REMARKS

This response follows the sequence of the Office Action dated 10/14/2004, and, where practicable, is numbered identically.

Response to Paragraph 1 -- Specification

Fig. 1

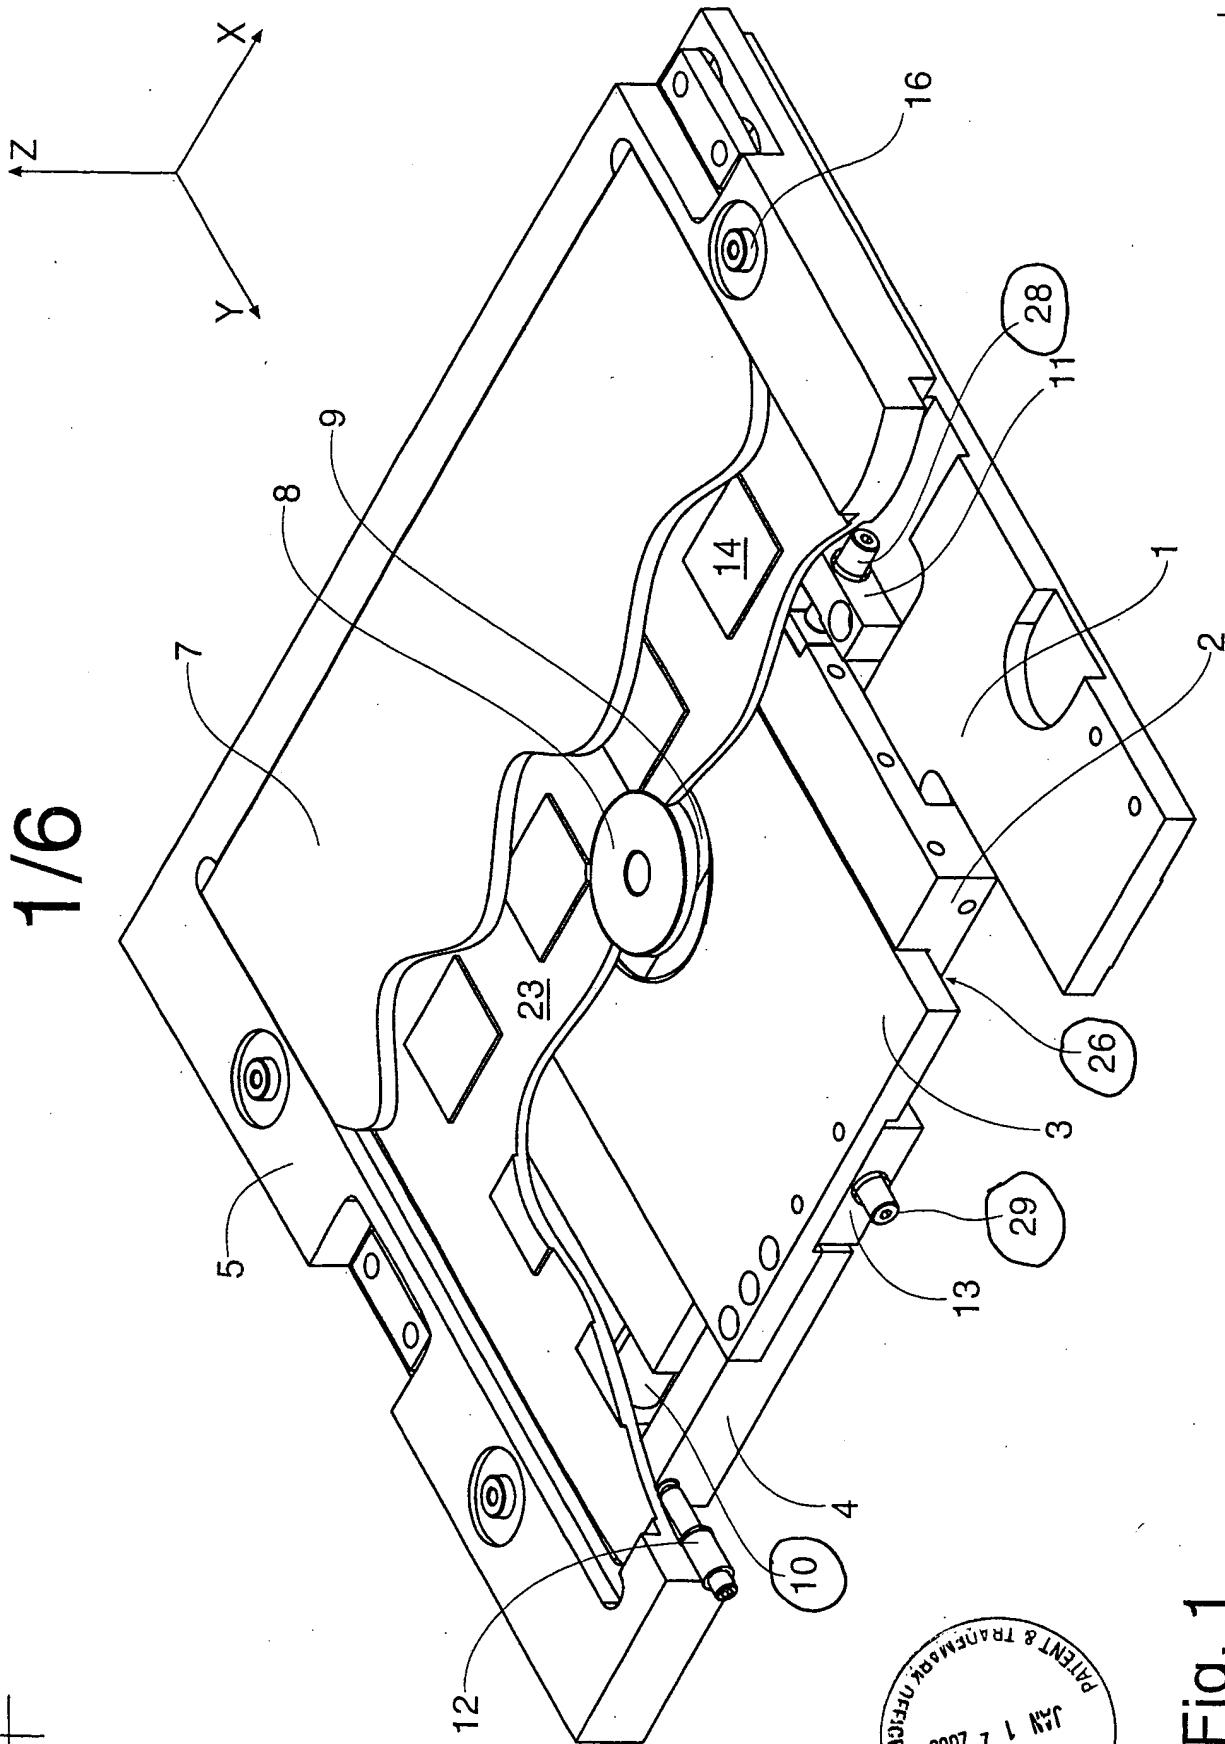
iii. A vacuum distribution channel pattern has appeared from first filing in Figs. 1 and 2. This vacuum distribution channel pattern is now identified by

reference characters 23 in Figs. 1 and 2. Yaw vacuum diffuser bracket 5 supports vacuum diffuser plate 7 on the tops of diffuser plate support islands 14. Vacuum paths around diffuser plate support islands 14 include representative channels in vacuum channel pattern 23 shown in Figs. 1-3. .

shaft and the vacuum channel means.. The amendment limits Claim 7 to separate x preload and y preload as in Claim 6. The amendment also eliminates confusion as to "...vacuum channel means juxtaposed with said yaw shaft." Yaw shaft 8, identified in Fig. 1, Airflow related to the vacuum is in the channel pattern 23 surrounding the centrally-located yaw shaft 8. and the archipelago of diffuser plate support islands 14 in the yaw vacuum diffuser bracket 5. Vacuum diffuser plate support islands 14 provide hard supports; the relief 25 locates vacuum diffuser plate 7 against x or y motion and locates its top surface as an apron coplanar with the top surface of yaw vacuum diffuser bracket 5, and the vacuum airflow is through vacuum diffuser plate 7, around vacuum diffuser plate support islands 14 and through yaw shaft 8 into a vacuum source which preferably is the vacuum of the moving platform of the stage.

Fig. 3

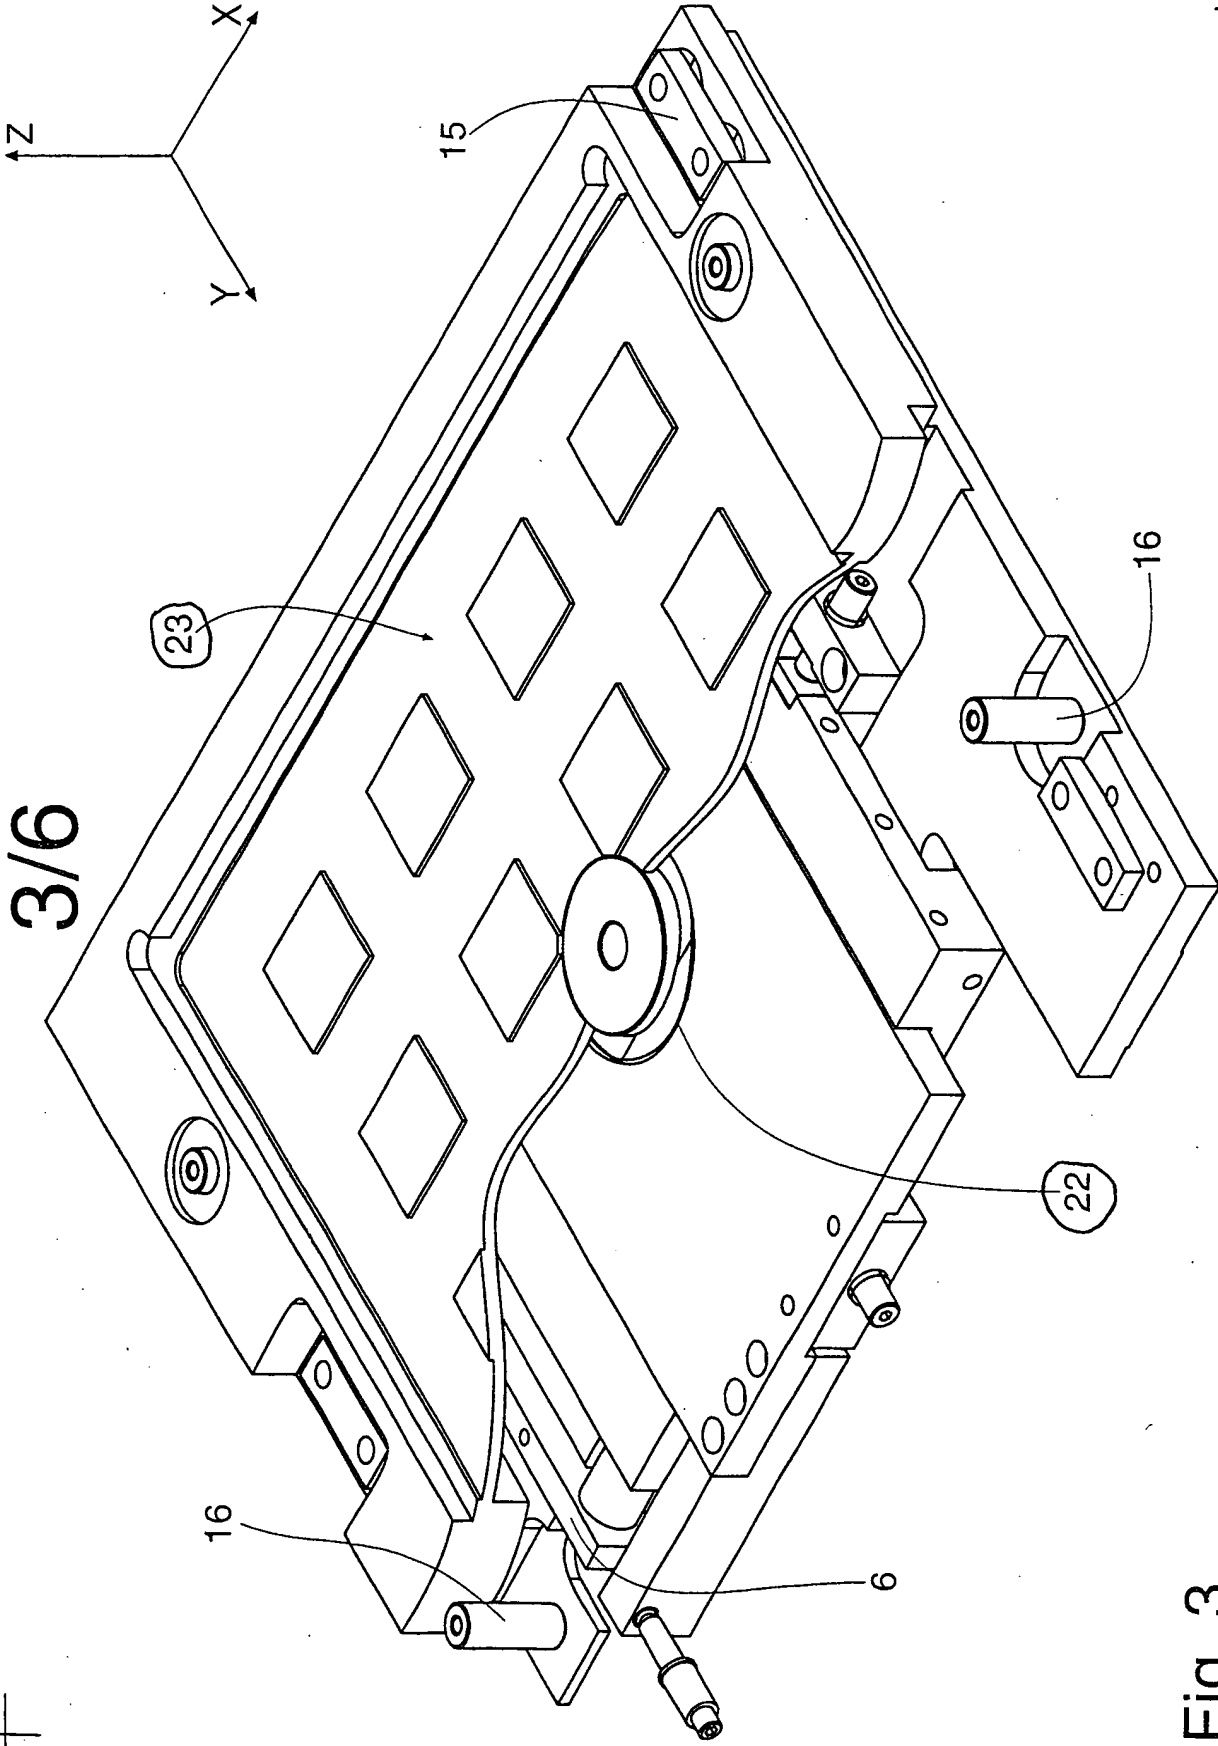
ii. The central yaw shaft opening, which has continuously appeared in Figs. 1-5 as filed, is now identified with reference character 22 in Fig. 3.

Fig. 2

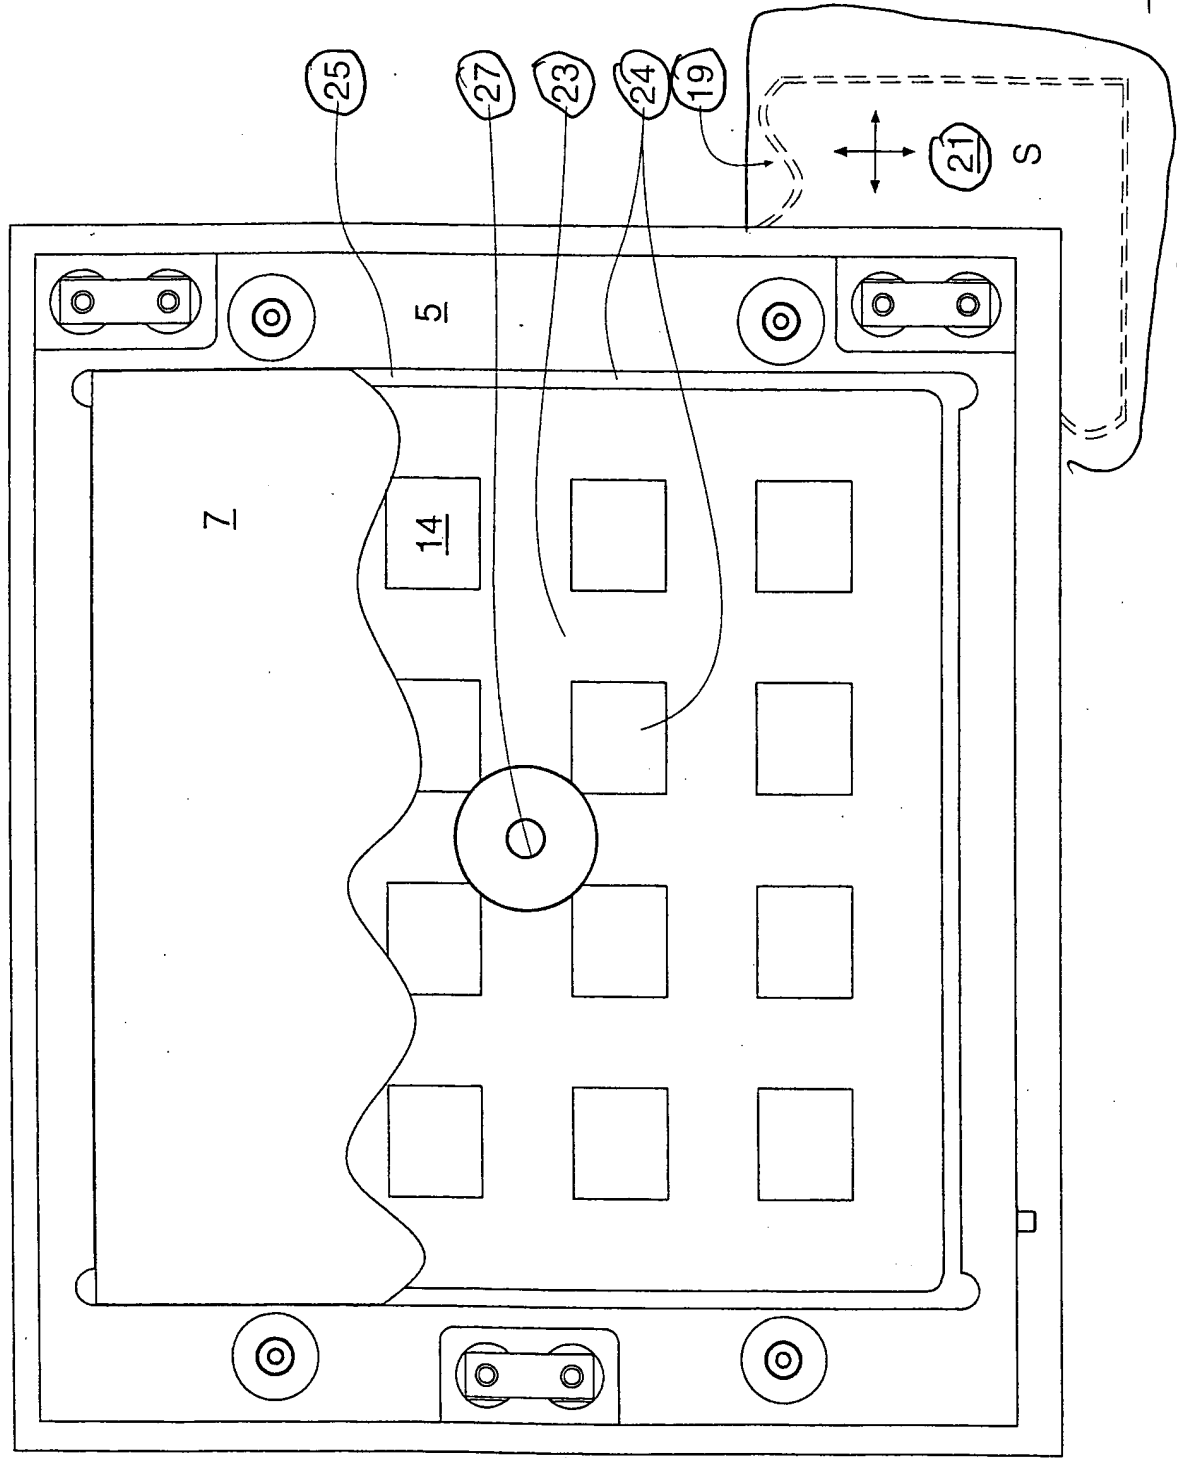
i. A high-resolution stage 19, with its top surface 21 now marked by designation “S,” now appears in Fig. 2. Such high-resolution stages are devices sold as such, and are typically used in microelectronics imaging systems. Note that the high-resolution stage is not positively stated as an element in any claim, but is mentioned in the preamble of claim 1 as context. Another mention, again in context, has been deleted at the end of claim 1. Again in context, the stage is mentioned in several dependent claims where claim features make possible various adjustments of alignment while so mounted. To make clear that the stage is not positively mentioned as an element of invention embodiment construction, but rather mentioned as a mounting location context, the term “such” now is used rather than the confusing term “said.” Counsel apologizes for the confusion.

viii. Epoxy cement is now shown as smears 24 atop representative positions of the peripheral vacuum diffuser plate locating relief 25 diffuser plate support island among the archipelago of such islands including diffuser plate support island 14 in Fig. 2.

All drawing corrections are included in the substitute sheets 1, 2 & 3 of drawings, which the Examiner is asked to approve. Except for the addition of the precision stage 19 and its surface 21, shown in dashed lines as context (not positively stated as an element in any claim) in Fig. 2, all changes are additions of reference numerals to identify items already shown in the figures and already referred to in the text. These changes place the patent application in full compliance with all rules requiring placement and identification in the figures of items previously described elsewhere in the written description and claims – thus no “new matter.”
